TO: Mercedes-Benz Dealer Principals, General Managers, Sales Managers, Service Managers, Parts Managers	FROM: Gregory Gunther, Department Manager, Vehicle Compliance and Analysis, Engineering Services
RE: <b>Service Campaign Launch Notification</b> <b>Replace Transmission Bearing Cover</b> <b>MY20-21 GLA-Class and GLB-Class (156/247 platform)</b>	DATE: December 9, 2022

Campaign No. 2022110007, December 2022

SUBJECT: **Model GLA-Class and GLB-Class (156/247 platform)**  
**Model Year 2020-2021**

## **Replace Transmission Bearing Cover**

Figure 1

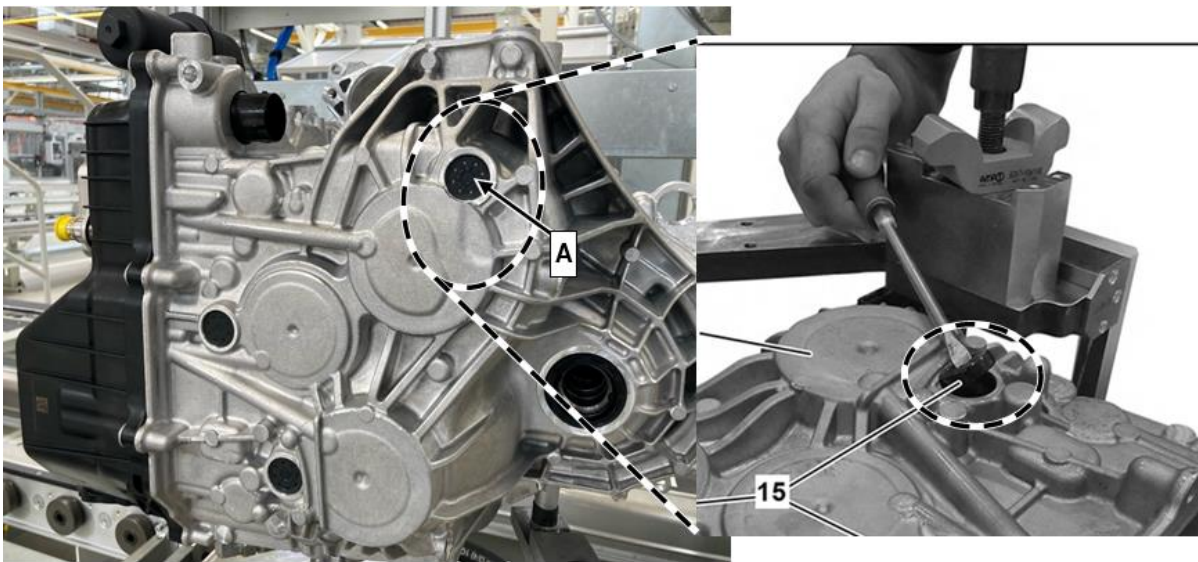
1. Remove engine with transmission.
  - i** For basic data, see AR01.10-P-2401\*.
  - i** \* Select the WIS document according to the vehicle model.
2. Remove bearing cap (A, Figure 1) from transmission using a suitable tool.
  - i** The bearing cap will be replaced by a **new aluminum bearing cap**.

3. Insert new aluminum bearing cap up to end stop and hammer in slightly.
  4. Assemble in reverse order.
-
